## SYDNEY WEST CENTRAL PLANNING PANEL

<b>JRPP No</b>	2016SYW124
<b>DA Number</b>	DA 2016/127
<b>Local Government Area</b>	Cumberland
<b>Proposed Development</b>	Demolition of existing structures; construction of 5 mixed use buildings ranging in height between 10 and 17 storeys over 2 separate basements ranging between 2 and 5 levels accommodating a total of 562 residential units; 7,876m <sup>2</sup> of commercial floor; 742 carparking spaces; construction of a new road; and Torrens subdivision into 5 lots
<b>Street Address</b>	233-259 Merrylands Road and 52-54 McFarlane Street, Merrylands
<b>Applicant/Owner</b>	Stockland Merrylands Court Pty Ltd
<b>Number of Submissions</b>	Five
<b>Regional Development Criteria (Schedule 4A of the Act)</b>	Capital Investment Value \$238,370,000 (>\$20 million)
<b>List of All Relevant s79C(1)(a) Matters</b>	<ul style="list-style-type: none"> <li>• State Environmental Planning Policy No. 55 – Remediation of Land</li> <li>• State Environmental Planning Policy No. 65 – Design Quality of Residential Apartment Development</li> <li>• State Environmental Planning Policy (BASIX) 2004</li> <li>• State Environmental Planning Policy (Infrastructure) 2007 (SEP

Figure 5. Height of Building Map (Source: Sutherland and Associates Planning, 2016)

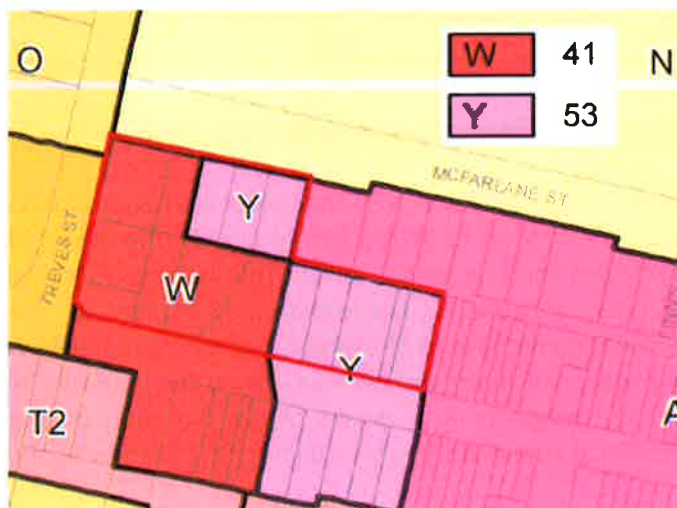
The permissible maximum height of building varies from 41m to 53m, generally from west to east across the site as shown in figure 5 below.

As shown in the figures above, Buildings A and B exceed the height limit by up to 11.87m (or 29%), while the height limit is varied by up to 18.1m (or 44%) over the lower 41m limit where proposed Building D straddles the two height zones. The variations for Buildings C and E of 4.8m and 1.4m, respectively, are generally confined to rooftop plant and parapet. In addition the DCP identifies a maximum number of 16 storeys over the 53m height zone and 12 storeys over the 41m height zone, which also provides a guide to the potential built form anticipated under the Holroyd LEP height limit. In terms of the DCP limit on number of storeys, this equates to an additional part 4 storeys for Building D, 2 storeys for Building B and 1 storey for Building A.

Figure 8. FSR Map (Source: Sutherland and Associates Planning, 2016)

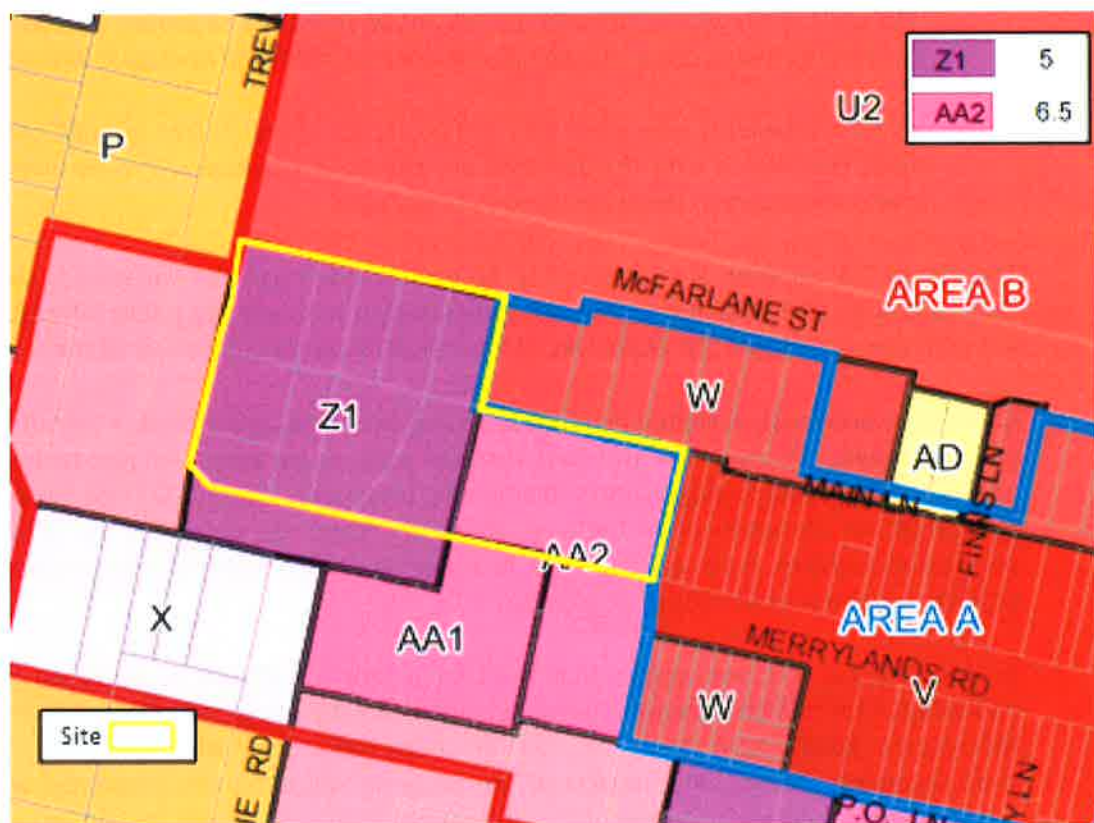
The total permissible FSR is 5:1 over the western portion of the site and 6.5:1 over the eastern portion of the site as shown in the figure below.

Residential floor space is limited to 3.3:1 and 4.8:1 over the western and eastern portions, respectively. The proposal results in a residential floor space of 3.68:1 over the western portion (11.4% variation) or an additional 3,323sqm of residential gross floor area. However, this is offset with a commensurate 3,323sqm reduction over the eastern portion or an FSR of

3.89:1. Therefore, there is no variation to maximum residential floor space on an aggregated basis. Overall, the total commercial and residential FSR of 4.4:1 is well below the maximum on both an individual and aggregated basis.

The Clause 4.6 variation is considered to be well founded and the variation is supported. Council is also satisfied that the proposed development will be in the public interest because it is consistent with both the objectives of the standard and the objectives of the zone.

**Figure 9. Overlay of DCP scheme versus proposal (Source: Turner Architects, 2016)**

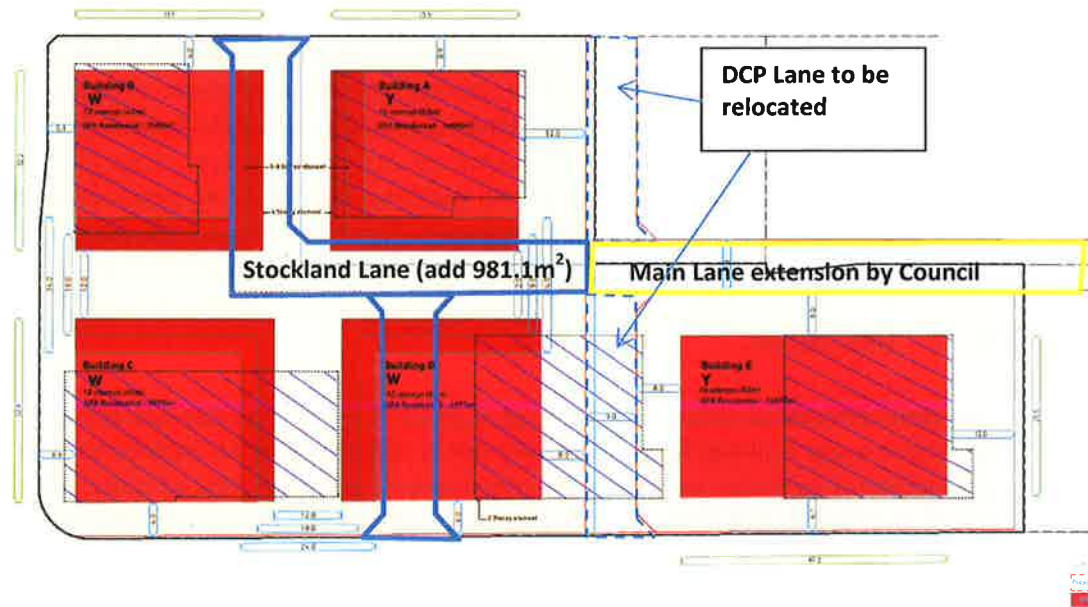
As shown in Figure 9 below, the proposal involves a variation to the laneway layout identified under Holroyd DCP 2013 by extending Main lane an additional 64m to the west and shifting the north-south laneway away from the adjoining property to be wholly within

the site. Further it is noted that a total laneway width of 8m is required as per Section K-K under the DCP, but a 9m width is proposed in line with Council's engineering requirements.

The resultant change to the built form massing and configuration across the site is generally consistent with the desired future streetscape for the McFarlane Street and Merrylands Centre precinct under both the current and draft Holroyd LEP and DCP. In this regard, Council's Urban Design consultant has reviewed the proposal and raises no objection subject to a condition requiring the corners of ground floor commercial units RT312 (Building C) and RT114 (Building A) to be curved to allow better sightlines and improve safety and security around the dog-leg in the north-south lane. This would further reinforce the activation of the laneway and allow for increased outdoor dining space. Further, Council's Engineering and Traffic sections have reviewed the proposal and raised no objections to the alignment of the laneway.
